# UNITED STATES PATENT AND TRADEMARK OFFICE

| APPLICATION NO. | FILING DATE | FIRST NAMED INVENTOR | ATTORNEY DOCKET NO. | CONFIRMATION NO. |
|-----------------|-------------|----------------------|---------------------|------------------|
| 10/700,490      | 11/05/2003  | Paul Stone           | 3229/4              | 6284             |

| <b>Office Action Summary</b> | <b>Application No.</b><br>10/700,490 | <b>Applicant(s)</b><br>STONE ET AL. |  |

## DETAILED ACTION

FIG: 1

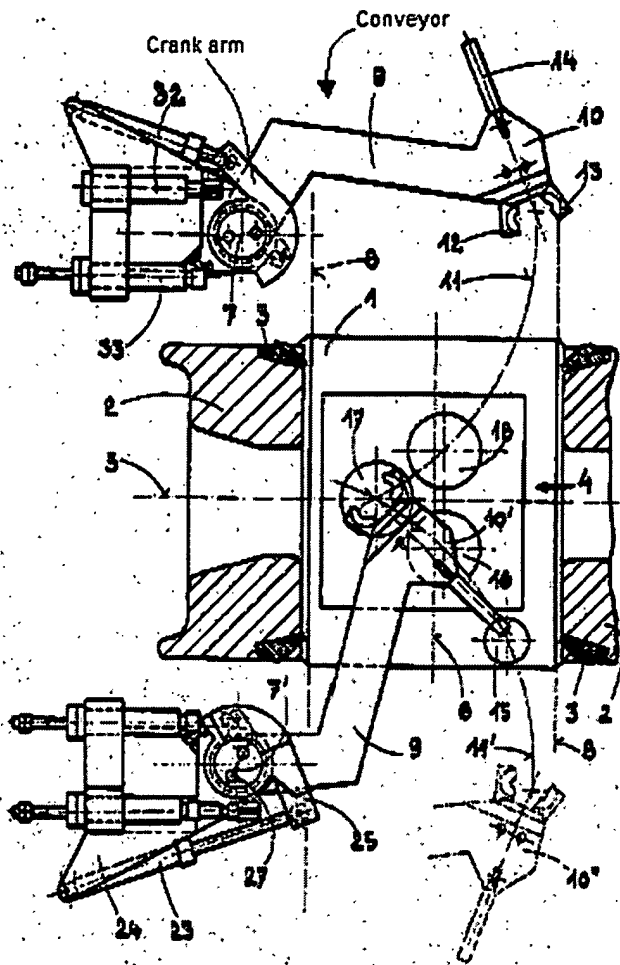
1. Claims 12-16 and 22 are rejected under 35 U.S.C. 103(a) as being unpatentable over Cvacho et al (U.S. Patent # 3,628,368) in view of Bachmann (U.S. Patent # 3,824,833) in further view of Nakamura (JP Patent # 5-177291) and Fuchs Jr (U.S. Patent # 4,644,775) and Takayama (U.S. Patent # 6,192,285 B1). Cvacho et al discloses a work piece positioning apparatus and machine having a conveyor (cup receiver 57) for precisely positioning a cup-shaped workpiece into position at a die (60) from a supply source. Cvacho et al also discloses a punch (55, See FIG 10) with a moving means comprising of a motor (34), a housing assembly (53) and intermediate wheels, linkages, and drive connections (See col. 2, line 59). Cvacho et al does not disclose a conveyor that is capable of loading and unloading a workpiece from the die station. However, Bachmann discloses a forging press having a conveyor (See FIG 1) to load and unload workpieces to or from a forging working space (4). The generally J-shaped conveyor (See FIG 1A) of Bachmann comprises of a first pivot assembly (pivot spindle 7), a movable robot arm (handling lever 9) with a crank arm (See FIG 1), and an end effector (grippers 10) and is actuated by a piston-cylinder system (23, See col. 5, line 56).

Therefore it would have been obvious to one of ordinary skill in the art at the time the invention was made to modify Cvacho et al with a conveyor which is capable of loading and unloading a workpiece from a supply source to a die station and then to a storage area as taught by Bachmann in order to effectively load and unload a workpiece in a timely and efficient manner.

FIG: 2

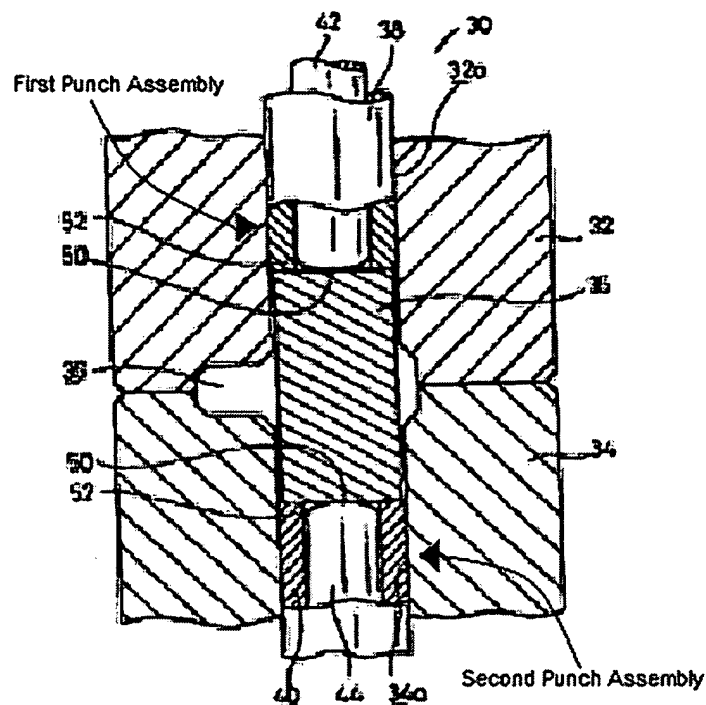
2. Cvacho et al does not disclose a first and second punch assembly having inner and outer punches. However, Nakamura discloses a closed forging device having a first and second punch assembly (See FIG 2) each comprising of an inner punch (42, 44) that is surrounded by the outer

punches (40) and is in sliding engagement therewith. Nakamura also shows in FIG 2 each inner (42, 44) and outer (40) punch share a common axis and the punch assemblies are in a confronting relationship to one another.

Although the apparatus of Cvacho et al only contains a single punch the complexity of the drawing was simple and two punches was not needed, however Nakamura teaches the use of multiple punch assemblies to form complex shapes. Therefore it would have been obvious to one of ordinary skill in the art at the time the invention was made to modify Cvacho et al with the multiple punch assemblies as taught in Nakamura in order to be capable of forging complex shapes at a single station.

FIG: 3

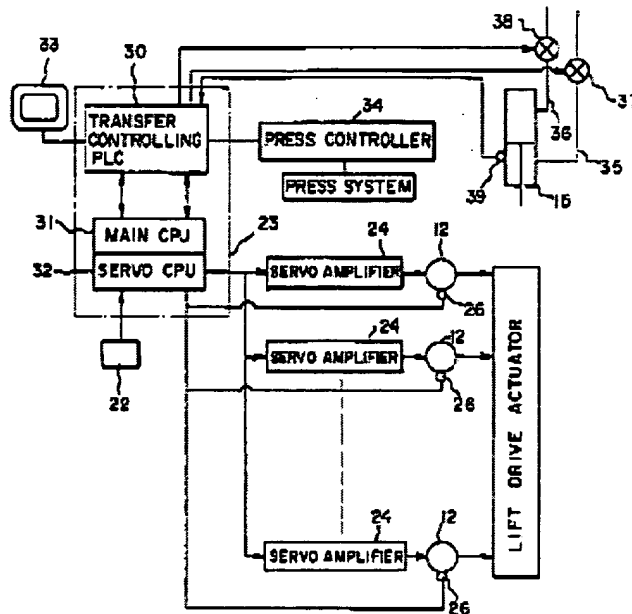
4. As stated in Fuchs Jr it is know in the art to use a control means, as disclosed by Takayama, for controlling the dies and conveyor of Cvacho et al. Takayama discloses a controller for work transfer systems having a programmable logic controller (transfer system controller 23) comprising of a transfer controlling PLC (30), a main CPU (31) and a servo CPU (32) for controlling the servo motor (12) of the feed bars (11) (See FIG 3 and col. 5, line 38).

Therefore it would have been obvious to one of ordinary skill in the art at the time the invention was made to modify Cvacho et al with a programmable logic controller and servo actuator for rotation of the robot arm as taught by Takayama in order to provide efficient movement of the punches and conveyor.

FIG. 4

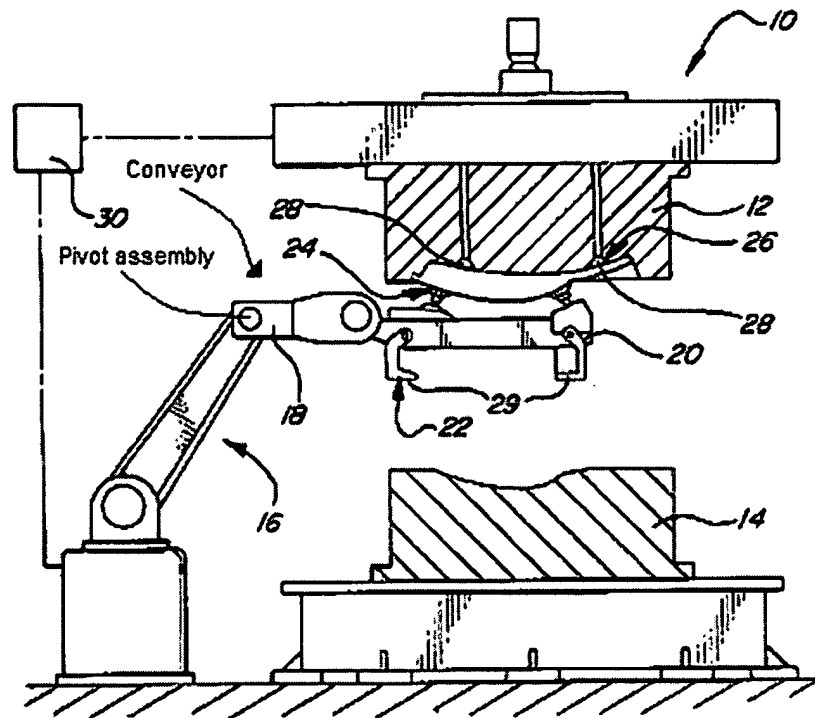
2. Bachmann (U.S. Patent # 3,824,833) discloses a forging press having a conveyor (See FIG 1) for conveying a forged product to and from dies and the working space (4). The conveyor (See FIG 1) comprises of a pivot assembly (pivot spindle 7), a movable robot arm (handling lever 9) with a crank arm (See FIG 1 above), and end effector (grippers 10) with two movable jaws (12, 13) and is actuated by a piston-cylinder system (23, See col. 5, line 56). Toeniskoetter (U.S. Patent # 6,125,683) discloses a closure panel hemming system having a conveyor (See FIG 4). The conveyor (See FIG 4) comprises of a pivot assembly (See FIG 4), a movable robot arm (18) with a crank arm (robot 16), an end effector (20) and first and second carrier elements (pivoting clamping fingers 29).
